VARIANCE APPLICATION SUMMARY

RE: Project Esterby Pool Pavilion, 400 Braemer Court. Gahanna, Ohio 43230

PLANNING COMMISSION STAFF REPORT

Project Summary – 400 Braemer Court

Elevation Side View ISSUE PROJECT CLIENT
6/27/24 REV 1 John Esterby

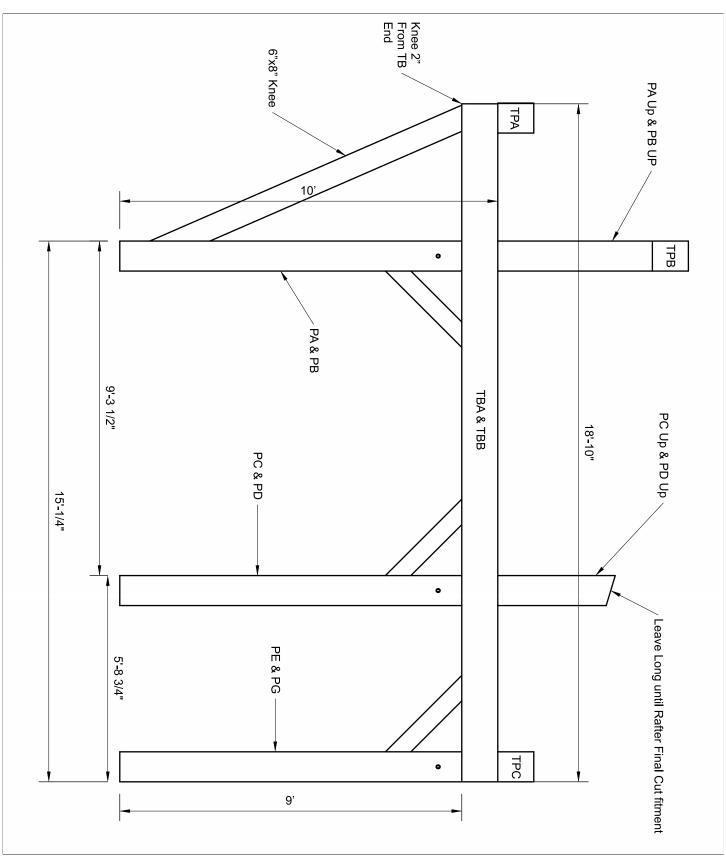
The Zoning Code allows a maximum height of 15 ft for all accessory structures in residential districts and 35 ft for primary structures. The pool house is 16.5 ft tall at the highest part of the roofline, which is 6 inches less than originally proposed. The applicant states they are requesting the variance because increasing the height will allow more sun onto the deck. There is a 4 ft tall fence around the backyard also tall trees to the rear of the property.

- 1. 1103.07(e) Large Lot Residential
 - a. The maximum height for accessory structures is 15 ft.
 - b. The pool house is 16.5 ft tall.

Staff recommends disapproval of the variance since there are no special circumstances on the property that necessitate approving this variance. Staff is also unaware of any accessory structures above 15 ft in the surrounding area. The fence is also not nearly high enough to screen the pool house and there are no trees for screening on the north side of the property, where it is closest to the property line. The pool house is also very visible from the ROW as the house does not block the view and there are no trees or landscaping in front of it.
